Quality Control Report

Consultant **Wahib Medanat** Consultant Engineers
Site Name **Thahr Al Sarow Basic Boys - Jerash**
Package **Package 2**
Contractor **Dijlah Est. Construction Co.**
Tender No. **10/2019/USAID/SKEP/3/2**

Rep No. **QC-22 17**
Date **15 / 06 / 2022**

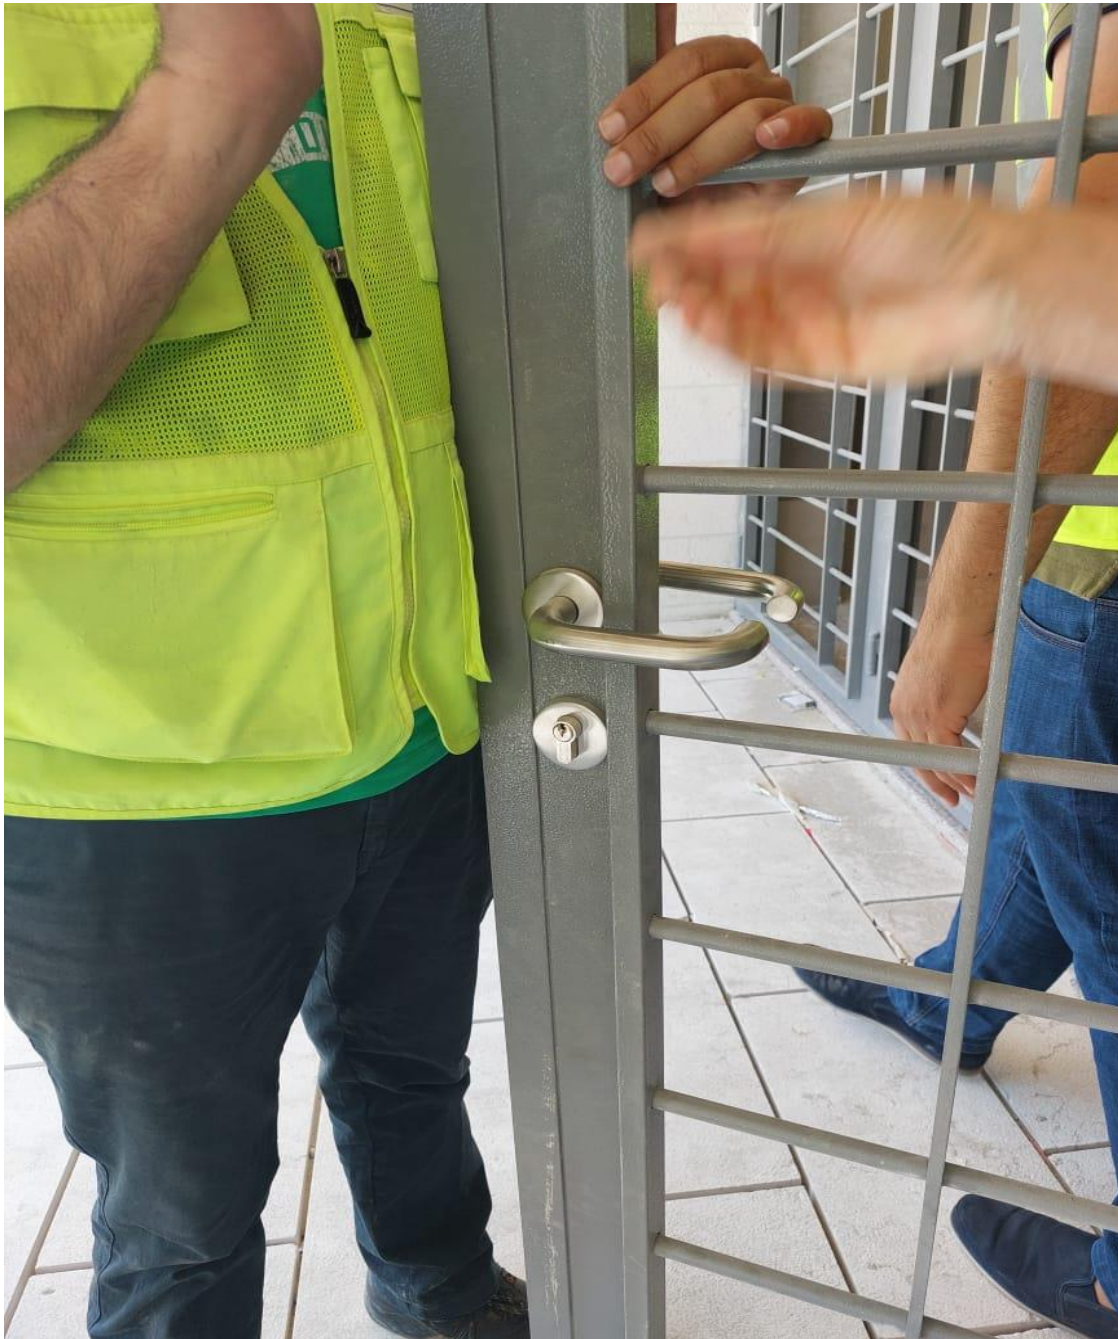
Removal of defected stones

Walls at entrance/tiling not in accordance to drawing
